MEMORANDUM DATE: November 2, 2021

RE: **1120 South Lakeside Drive**

TITLE: **HRPB Project Number 22-00100370:** Consideration of a Certificate of Appropriateness (COA) for the demolition of an existing structure and construction of a new ± 6,145 square foot single-family residence located at **1120 South Lakeside Drive**; PCN #38-43-44-27-01-051-0021. The subject property is located in the Single Family Residential (SFR) zoning district and is a non-contributing property in the South Palm Park Local Historic District. The future land use is Single Family Residential (SFR).

Exhibit A: Proposed New Construction – Front Elevation

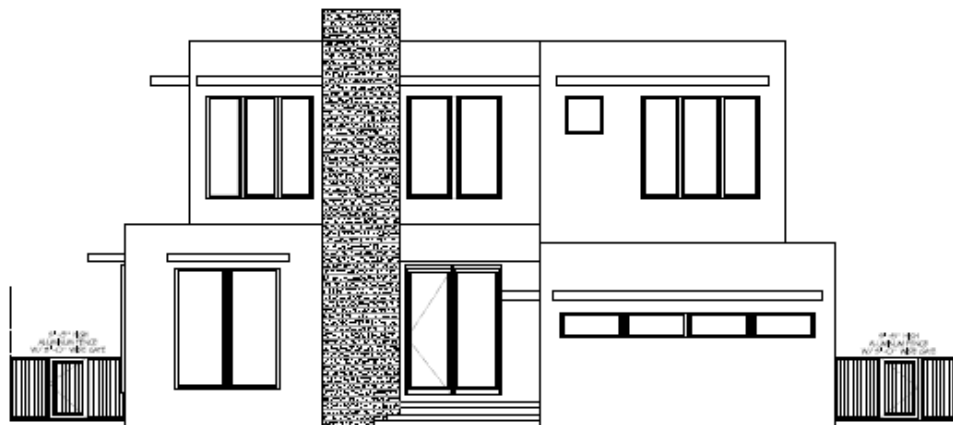
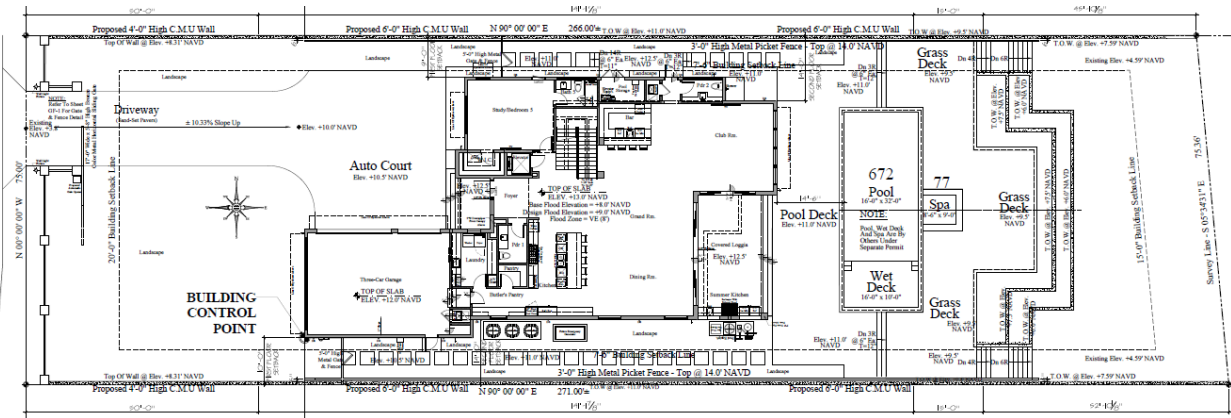
Analysis: The front (west) elevation largely avoids expanses of black façade, and the relationship of solids to voids is in harmony with neighboring buildings.

Analysis: The proposed design places the front entrance and porch towards the center of the front (west) elevation, which is in harmony with most other nearby buildings. The garage also projects out from the façade, which is common among surrounding buildings.

Analysis: The applicant has provided a streetscape showing the building in relation to those to either side of it. The building's height and massing are more substantial than most neighboring properties, but the building utilizes a staggered façade on the front elevation and has an increased front setback to help reduce its visual impact. Additionally, the building's height and massing are in harmony with that of the structure directly south of the proposed new construction.

Exhibit B: Proposed New Construction – Site Plan

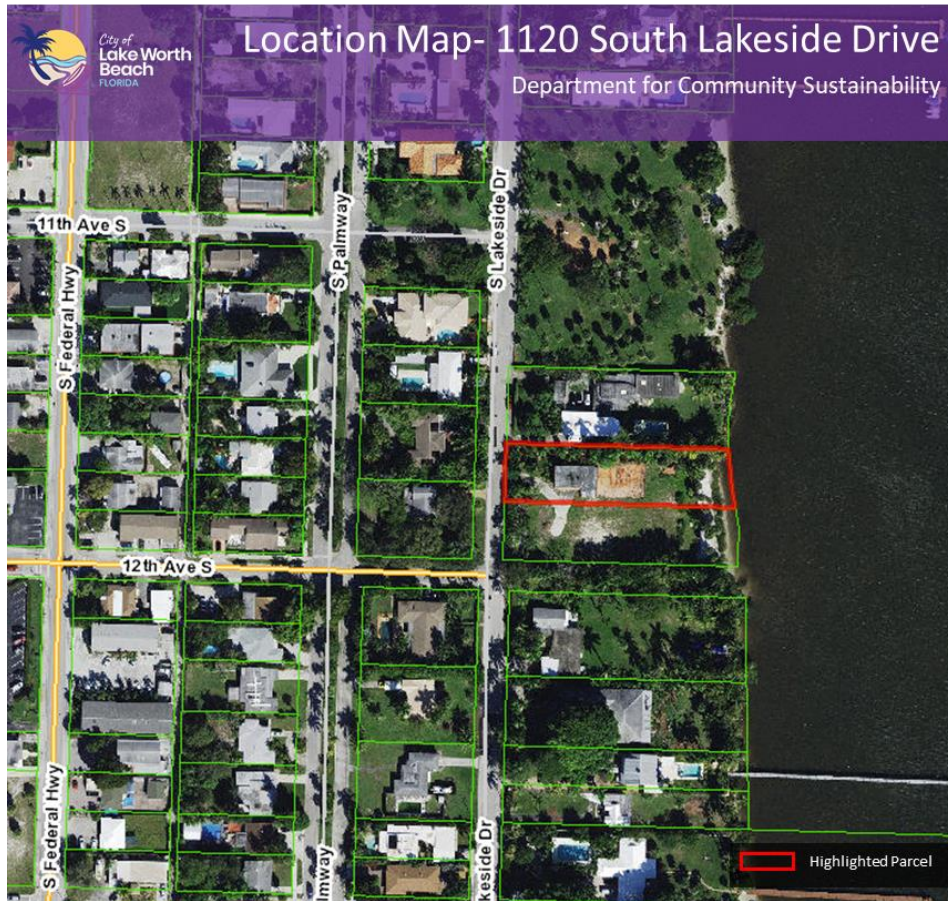
STAFF RECOMMENDATION: Staff is recommending that the HRPB discuss the compatibility of the fill and fencing along the side property lines. The fence proposed exceeds the maximum height permitted in the fence requirements. Terracing or sloping the proposed fill with complementary landscaping would provide for a more compatible development pattern to the existing single-family homes to the north and south of the property. An alternate recommendation is to reduce the total volume of fill on the property and just raise the structure. This would be consistent with the draft FEMA map floodplain requirements that have been proposed, but not adopted. Staff is recommending approval with conditions as provided on pages 12 and 13 except for the fill and fencing as proposed.

Analysis: The site features are largely appropriate for the structure and its context in the neighborhood, excluding the issues of fence height and fill. Terracing or sloping the proposed fill with complementary landscaping would provide for a more compatible site development to the existing single-family homes to the north and south of the property. The fencing and landscaping as proposed do not meet LDR requirements. Therefore, staff has proposed a condition of approval to address these concerns at building permit.

Analysis: In the submitted site plan, all mechanical equipment is placed outside the required side setbacks and in some cases is also screened from view. The mechanical equipment will not be visible from South Lakeside Drive.

Analysis: The proposal includes a landscape plan, which is part of the architectural drawings in **Attachment C**. The garage is side-loaded to the south and the garage bays face north rather than towards the street, obscuring the garage's prominence. The proposed site design is generally compatible with the surrounding neighborhood, excluding the previously mentioned issues with fence height at the side property lines. If approved by the Board, staff has included a condition that final site plan review and approval will occur at building permit.

- 1) The adopted FEMA map at the time of building permit submittal will be the governing regulatory map.
- 2) All fencing and gate locations, heights, and materials shall comply with the height and placement requirements of LDR Sec. 23.4-4 and shall be reviewed by staff at building permit. Fence and wall height are required to be measured from the natural grade. The fence height as currently proposed is not consistent with fence requirements in the LDRs.

- 3) Fill and drainage shall be reviewed at building permit by the City Engineer and the Department of Community Sustainability for consistency with all applicable drainage and fill requirements, including the requirement that no drainage is allowed to impact/flow onto adjacent property.
